Title of TENDER: SUPPLY OF SEWAGE TREATMENT PLANT ALONG WITH ALL THE ACC.AS PER SPEC. NO. ROS 6279, REV 00 RELEVANT ANNEXURES (MAIN SUPPLY, MANDATORY SPARES and ERECTION, COMMISSIONING PG TEST) FOR TSGENCO YADADRI TPS 5 X 800 MW PROJECT

**AMENDMENT ON SPECIFICATION FOR
PRE TREATMENT PLANT-YADADRI**

SPEC. NO.: ROS 6279, Rev:00

AMENDMENT NO # 1

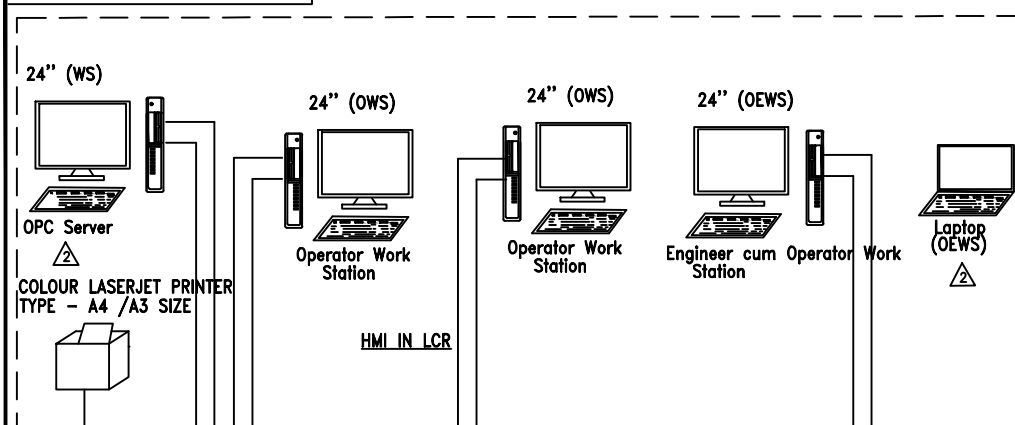
5.	--	200 of 1172	PLC Configuration ETP 4-WT-060-01143	PLC Configuration STP 4-WT-055-01143 (attached)
6.	2 a)	15 of 1172	a) Operation & Control of STP System shall be from STP PLC (BIDDER Scope) as well as through Backup Mimic Control Panel (BIDDER Scope).Detailed specification of PLC (KTPS VOLUME-VI, SECTION VI) and with respective PLC configuration diagram (4-WT-060-01143) consisting of master clock interface, dedicated OPC server, operator workstation, engineering workstation, Laptop, Optic fiber cables, PLB HDPE conduits, Light Interface units, FO patch cords etc are also part of the specification and bidder shall consider the same.	a) Operation & Control of STP System shall be from STP PLC (BIDDER Scope) as well as through Backup Mimic Control Panel (BIDDER Scope).Detailed specification of PLC (KTPS VOLUME-VI, SECTION VI) and with respective PLC configuration diagram (4-WT-055-01143) consisting of master clock interface, dedicated OPC server, operator workstation, engineering workstation, Laptop, Optic fiber cables, PLB HDPE conduits, Light Interface units, FO patch cords etc are also part of the specification and bidder shall consider the same.

7.	2.5 e)		e) A copy of this sheet "PLC configuration diagram (4-WT-060-01330) & "UPS single line Diagram (PE-DG-417-145-I004)" with bidder's signature and company stamp	e) A copy of this sheet "PLC configuration diagram (4-WT-055-01143) & "UPS single line Diagram (PE-DG-417-145-I004)" with bidder's signature and company stamp
